**Harker Heights
Planning and Zoning
Commission
Meeting & Workshop**

1. **P21-14** Discuss and consider a request for Preliminary Plat approval for the subdivision referred to as The Village at Nolan Heights, on property described as a 47.65 acre tract of land in Bell County, Texas, being part of the H.B. Littlefield Survey, Abstract No. 511, and being all of the called 47.626 acre tract of land described in a deed to Cactus Jack Development, Inc., recorded in Instrument No. 2020-064289, Deed Records of Bell County, Texas, generally located North of KISD Middle School No. 14, AKA Nolan Middle School along Warriors Path, Harker Heights, Bell County, Texas.

PLANNING AND ZONING COMMISSION MEMORANDUM

Below is the response to comments for The Village at Nolan Heights Preliminary Plat, received on April 7, 2021. Response to comment is in **bold**.

<table><tr><td>PM</td><td>JAT</td></tr><tr><td>DRAWING #</td><td>10</td></tr></table>

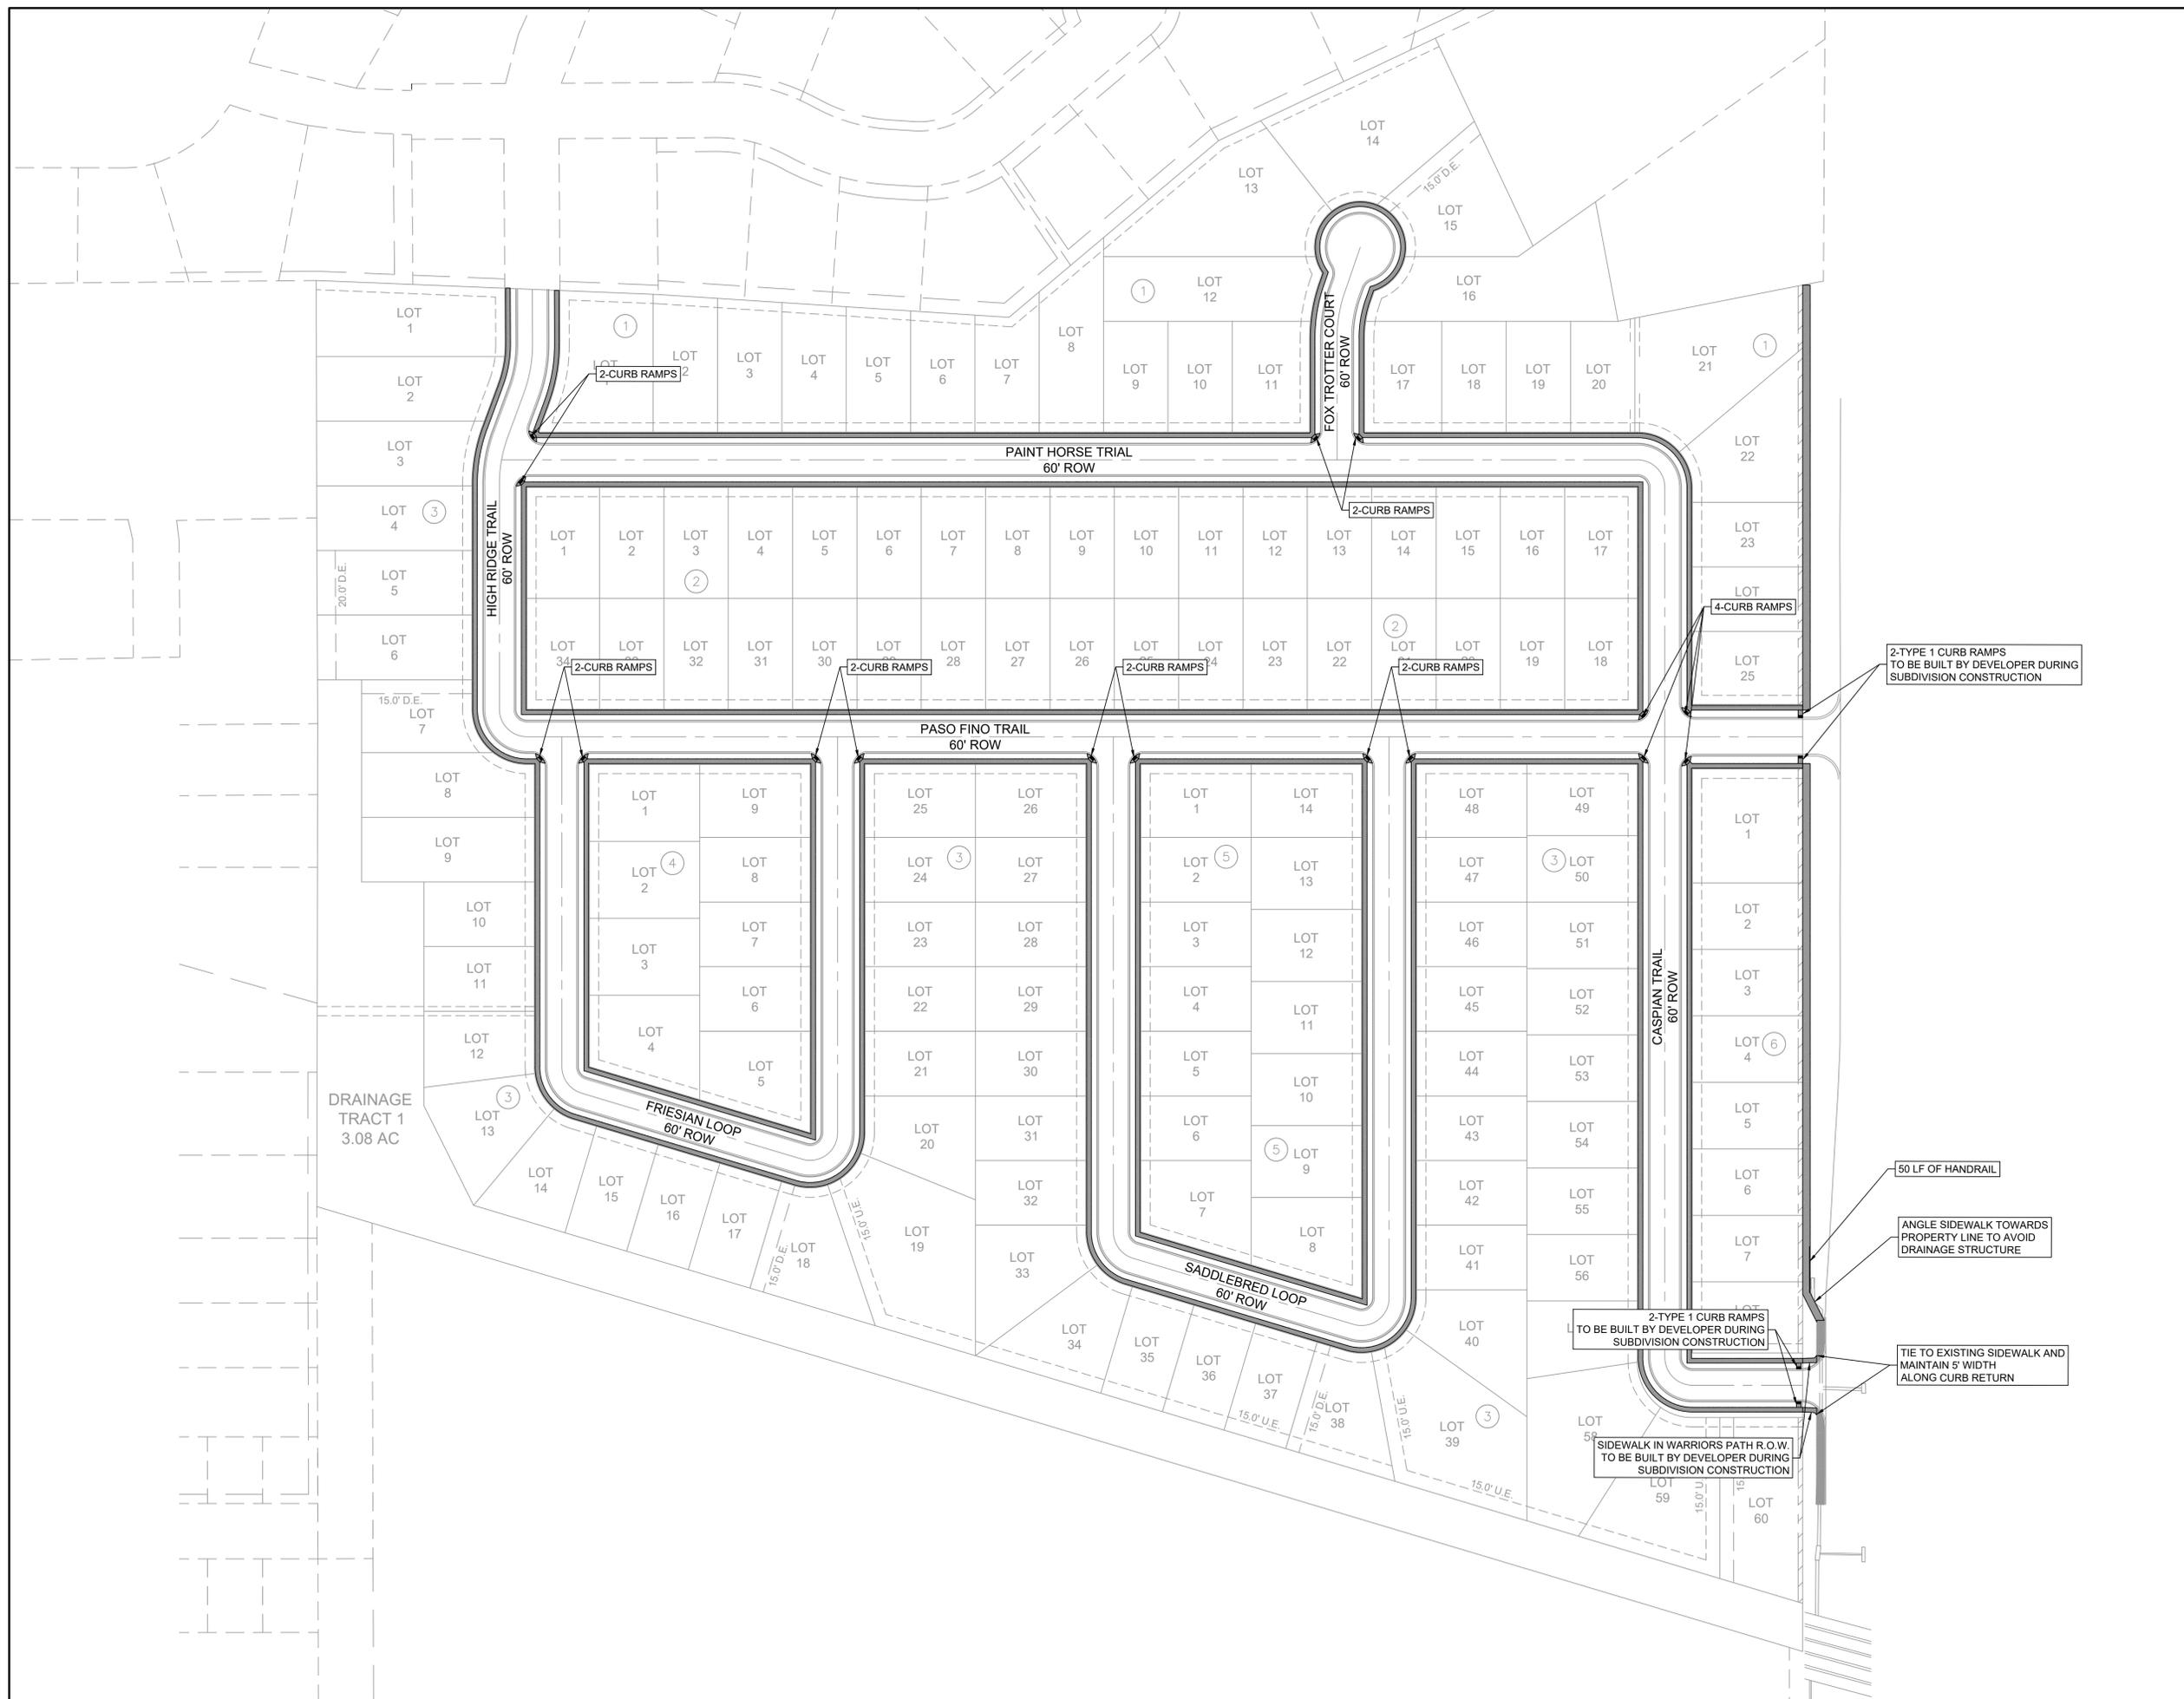
14. KR- On Sheet 10 clarify why sidewalks are not illustrated on both sides of the roadway, and add a note that the developer will be required to install the sidewalks across all drainage easement/tract crossings within the installation of the public infrastructure.

There was a printing error, that resulted in some of the sidewalks not showing up. This has been fixed to show sidewalks on both sides of the street. Note has been added.
